Access Compliance Report Public Rights-of-Way (Curb Ramps)

Intersection ID: 24109 Main Street: ARBOR POINTE DR Cross Street: PARK_RD Location: SW ADA ID: E4A224EA2EDD Ramp Type: PerpDiag Initial Pass/Fail: Fail **Overall Compliance: No Severity Score:** 12.5

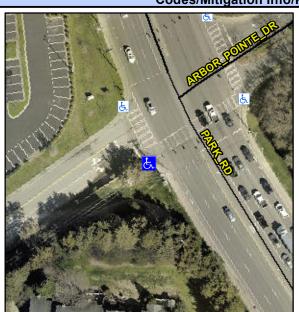
Field Measurements/Component Compliance					
Compliance Description		Data	Compliance Description		Data
N/A	Ramp Length (in)	60.0	No	Ramp Slope (%)	10.5
Yes	Ramp Width (in)	48.0	Yes	Ramp XSlope (%)	0.5
N/A	Flare Type LT	N/A	N/A	Flare Type RT	N/A
N/A	Flare Slope LT (%)	N/A	N/A	Flare Slope RT (%)	N/A
N/A	Flare Traversable LT?	N/A	N/A	Flare Traversable RT?	N/A
N/A	Landing Length (in)	N/A	N/A	DWS Provided?	N/A
N/A	Landing Width (in)	N/A	N/A	DWS Contrast?	N/A
N/A	Landing Slope (%)	N/A	N/A	DWS Length (in)	N/A
N/A	Landing X Slope (%)	N/A	N/A	DWS Full Width?	N/A
N/A	Landing Curb? (Y/N)	N/A	N/A	DWS Offset (in)	N/A
N/A	Shared Landing?	N/A			
N/A	Gutter Ponding?	N/A	N/A	Gutter Slope (%)	N/A
N/A	Gutter Lip Ht (in)	N/A	N/A	Gutter X Slope (%)	N/A
N/A	Painted X Walk1?	Yes	N/A	Painted X Walk2?	Yes
	X Walk 1 Direction	To NE		X Walk 2 Direction	To NW
N/A	X Walk 1 Width (in)	132.0	N/A	X Walk 2 Width (in)	178.0
	X Walk 1 Slope (%)	1.3		X Walk 2 Slope (%)	0.5

Possible Solutions: Remove & Replace Curb Ramp With Two New Directional Ramps or Equivalent. Surveyor Notes: N/A PROW/ADA: R304.2.2
